MACQUARIE PARK COMMERCE CENTRE WATERLOO RD

SECTION 75W ARCHITECTURAL DESIGN STATEMENT
AMENDMENT
S10758
JUNE 2018

1.3 S75W AMENDMENT AMENDED CONCEPT PLAN PROCESS

The following describes the amendments to the originally proposed section 75w Plan.

GROUND FLOOR PLAN

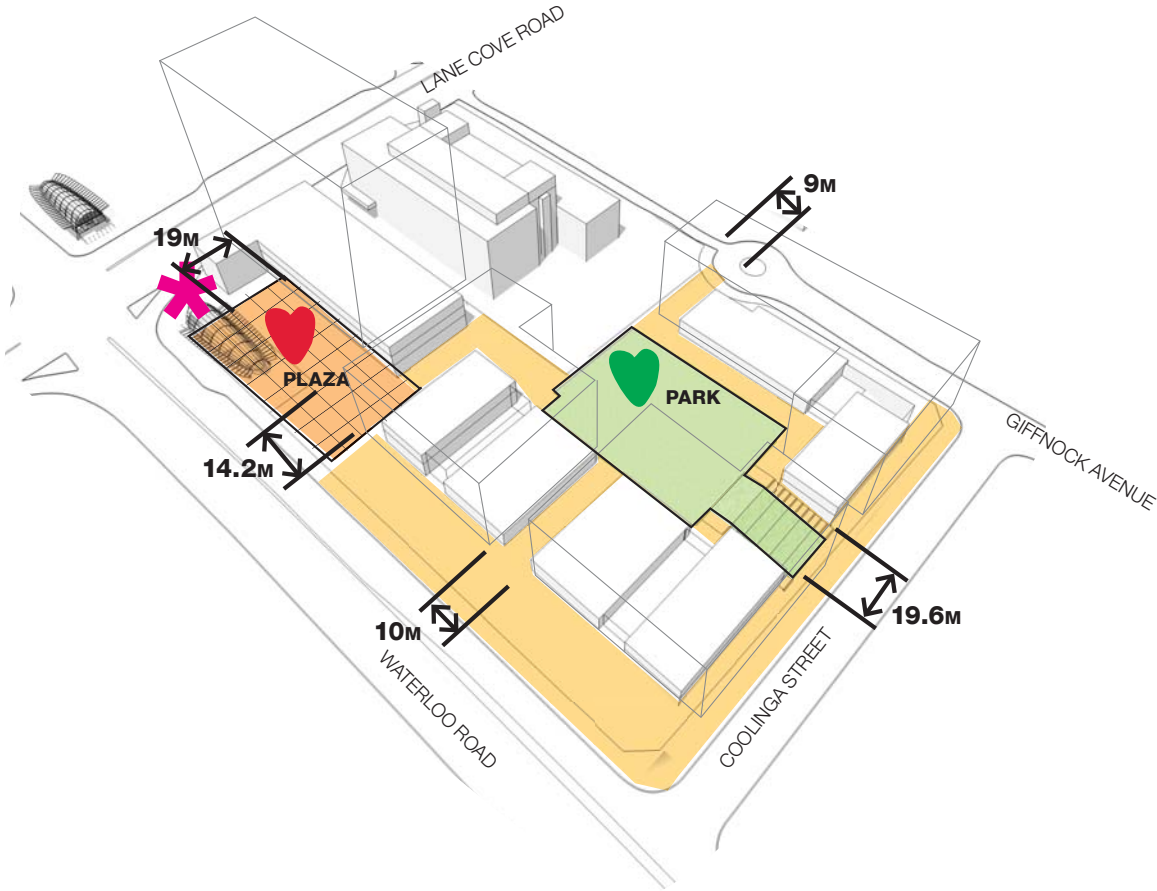
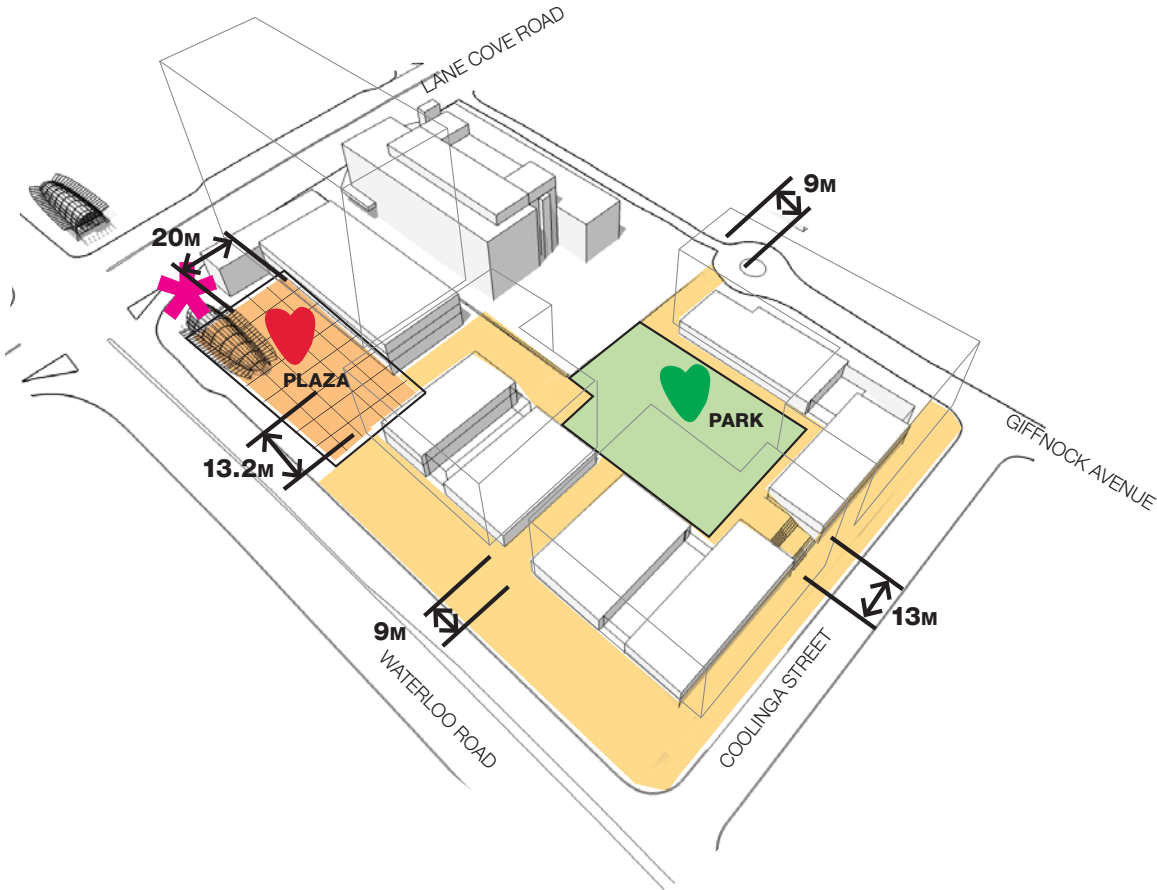
The amended ground floor concept builds on the key outcomes of the originally proposed concept plan.

The ground floor has been modified to increase public access through the site. By increasing laneways and providing a main landscaped entry along Coolinga St, the amended concept ground floor plan provides an expansive visual and physical connection to the central park.

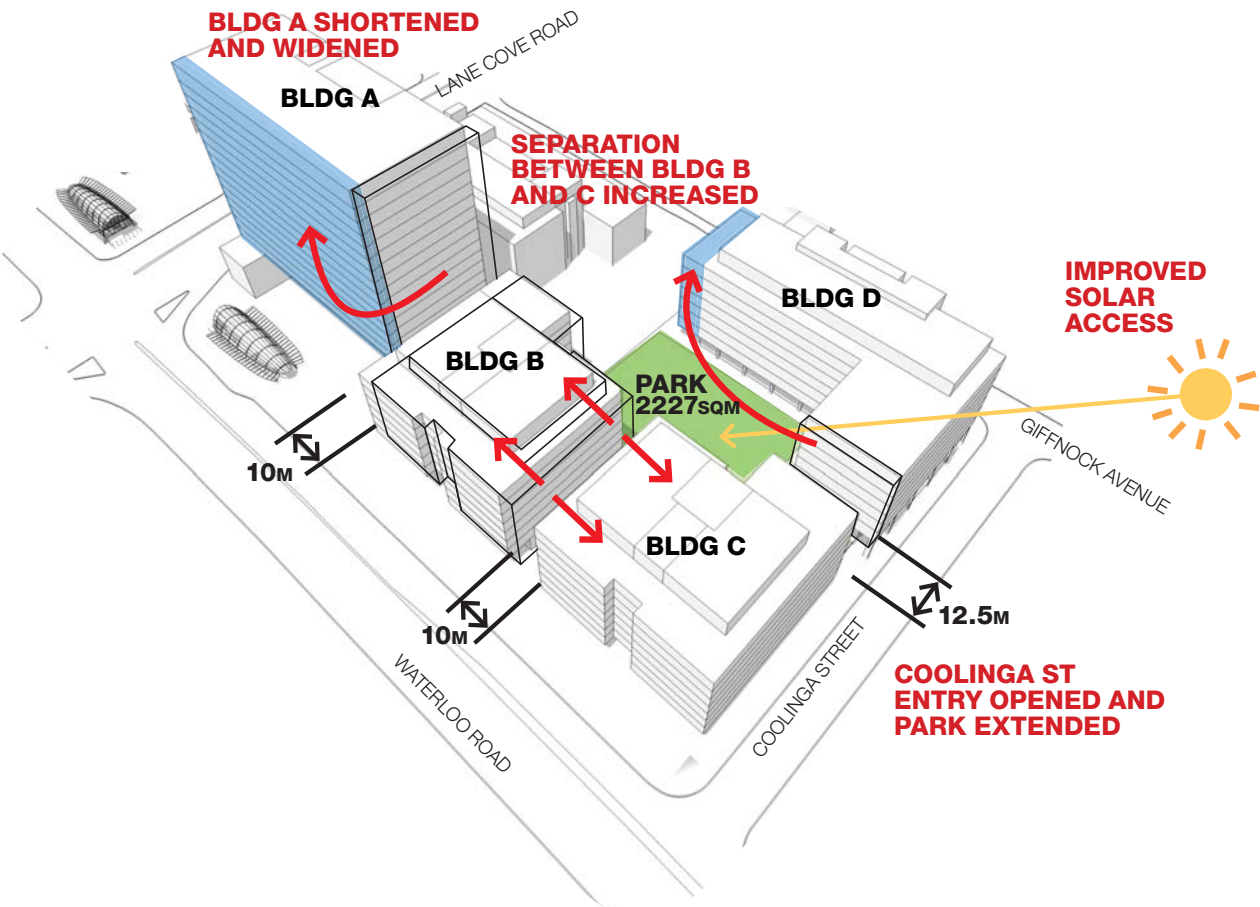
1. Increase the building separation to 10m along Waterloo Road

Building B & C separation increased 1m by moving Building B toward Building A

Building A's proportions have been adjusted to accommodate the increased building separation. Length was reduced by 2m and width increased by 1m

These adjustments achieved a minimum building separation of 10m to the Waterloo Rd frontage and 14.2m between Buildings A & B at ground level.

2. Central Park Street Connection

In order to provide a street connection to the central park, Building D's proportions have been adjusted by reducing the Coolinga St wing by approximately 3.5m and increasing the Giffnock Ave wing by the same.

These adjustments increased building separation on the Coolinga street frontage from 9m to 12.5m and increased the ground level entry to the park from 13m to 19.6m.

The Giffnock Ave frontage is setback 5m from boundary, the ground floor however, is kept as a 9m thoroughfare to maximise pedestrian flow with a 4m colonnade.

1.4 S75W AMENDMENT AMENDED CONCEPT PLAN SCHEME

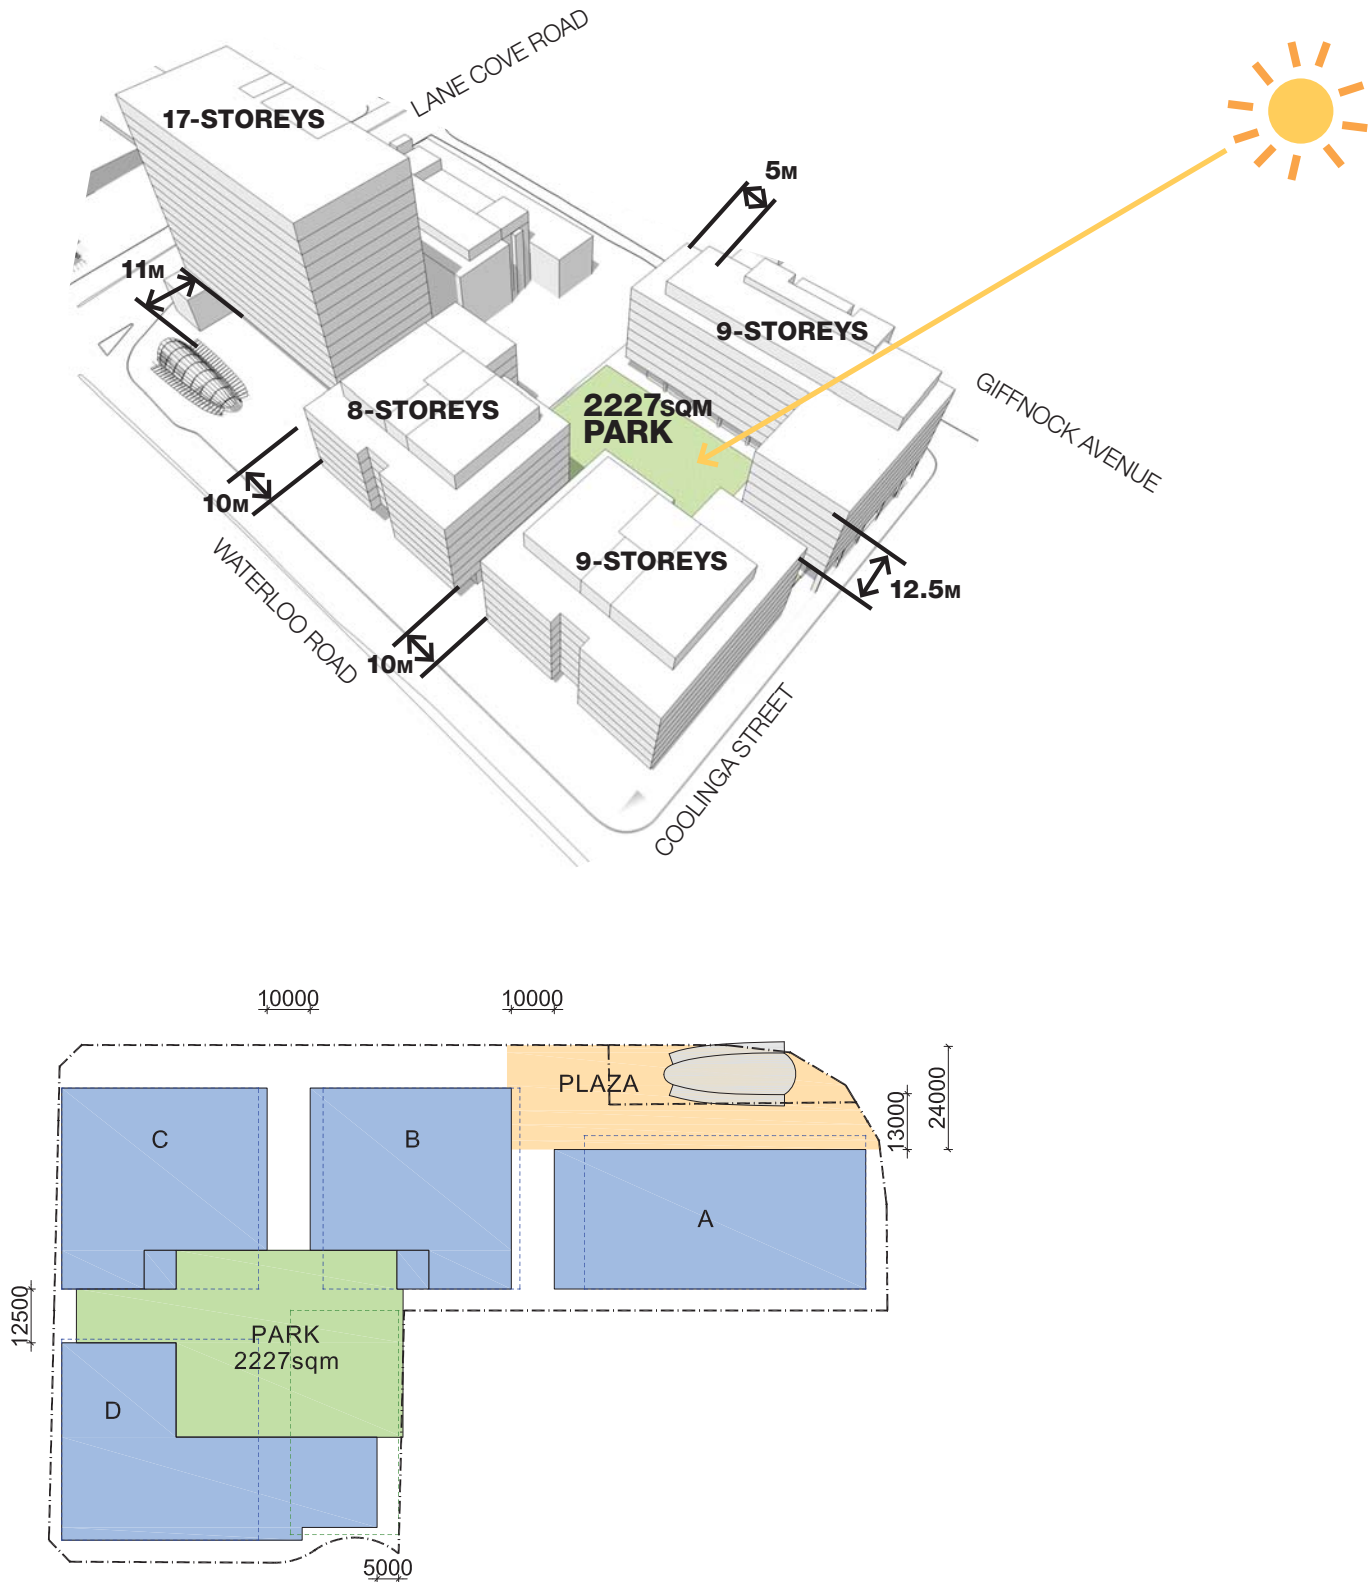
The amended Section 75W scheme retains the maximum building height of 17-storeys or 69.3m with a total GFA 83,368sqm equal to that of the approval.

Building separation is a minimum of 10m to Waterloo Road and increased to 12.5m on Coolinga Street, increasing to 19.6m at Coolinga Street and 14.2m between Buildings A&B when factoring in the colonnades at ground level.

The park increases to 2227sqm (50% uplift from the approved) and the station plaza increases to 3,865sqm (25% uplift from the approved).

This altered building configuration, in particular Building D, allows for additional daylight access throughout the year and public access to the central park. (refer to shadow study)

1.4 S75W AMENDMENT AMENDED CONCEPT PLAN SCHEME

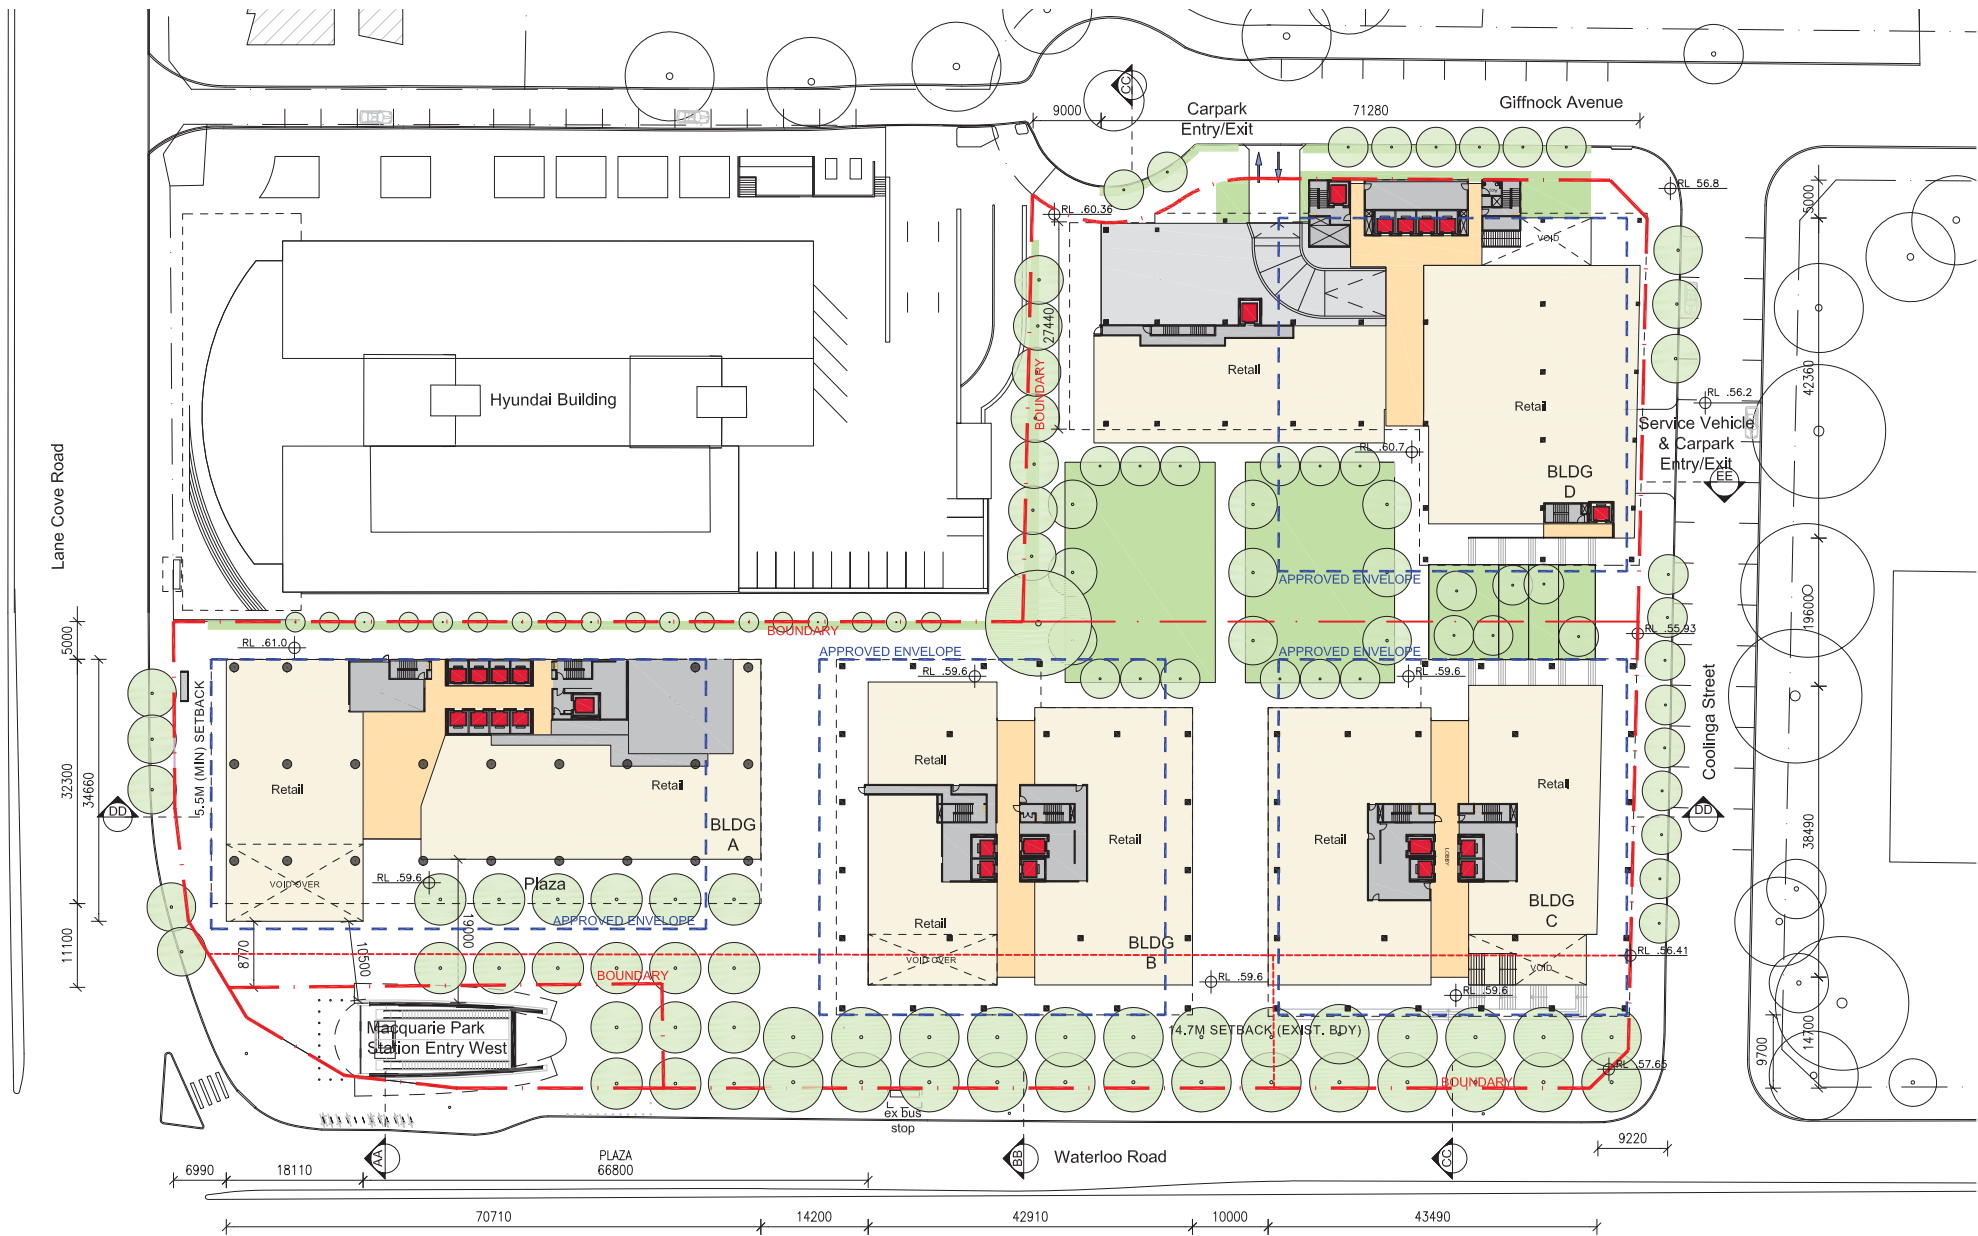
The amended ground plane concept evolved from the council UDRP process. A wider street entry to the park was desired to make the park more accessible to the public. This also increased solar access and landscaped area.

The scheme modifications from the approval create larger public open spaces, such as the central park fronting Coolinga Street, and activated vibrant areas by creating retail laneways. The laneways, while wider still offer an intimate shelter from the precincts larger spaces. Colonnades and covered walkways provide access throughout the site.
